2B	**Reviewed. Comments enclosed. Incorporate the comments and re-submit for review.**

TCE COMMENTS:

GA DRAWING
TYPE NO 01

TITLE - GATE				NIHVA TECHNOLOGIES PVT.LTD.PUNE
DWG NO - NTPL-000-PM-001-00-00-00				Website - www.nihva.com
	NAME	SIGNATURE	DATE	PROJECT NO - NTPL-000-PM
DRAWN	V.W		02-05-2025	PRODUCT - SINGLE SLIDING GATE
CHK'D	S.W.		02-05-2025	SITE LOCATION -
APPV'D	V.T.		02-05-2025	
if any queries contact - supportautomation@nihva.com				REVISION - / QTY - 1
ALL DIMENSION ARE IN mm			A3	SCALE / SHEET 1 OF 1

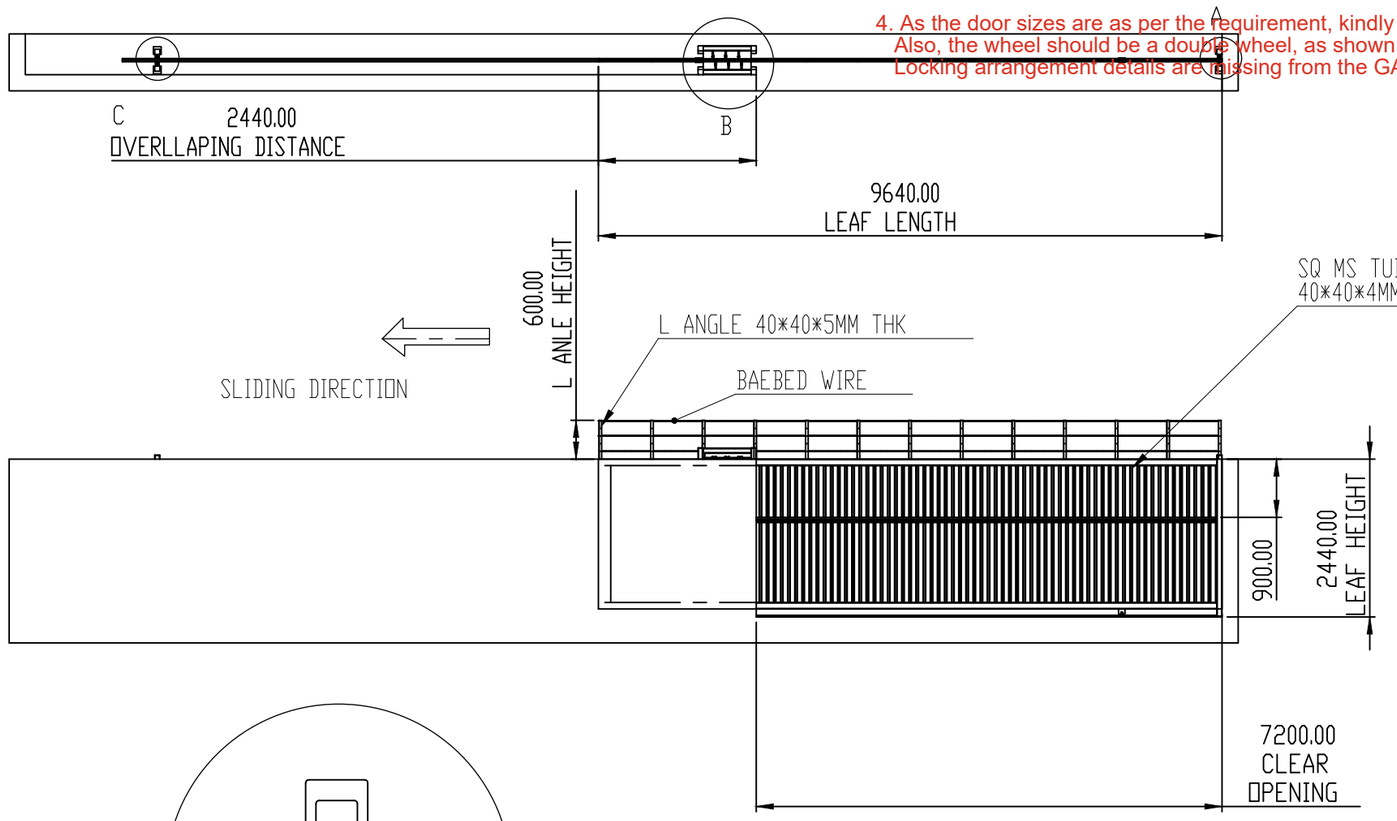
1. Please refer to the latest master layout for the exact site dimensions and space availability.
2. Barbed wire fencing above the sliding gate is under finalization with the Air India team. TCE will confirm shortly.
3. Please specify whether the elevation view is from the inside or outside. It is currently unclear.
4. As the door sizes are as per the requirement, kindly consider the weight and design the sections accordingly.
   Also, the wheel should be a double wheel, as shown in the architectural layout.
   Locking arrangement details are missing from the GA drawing.
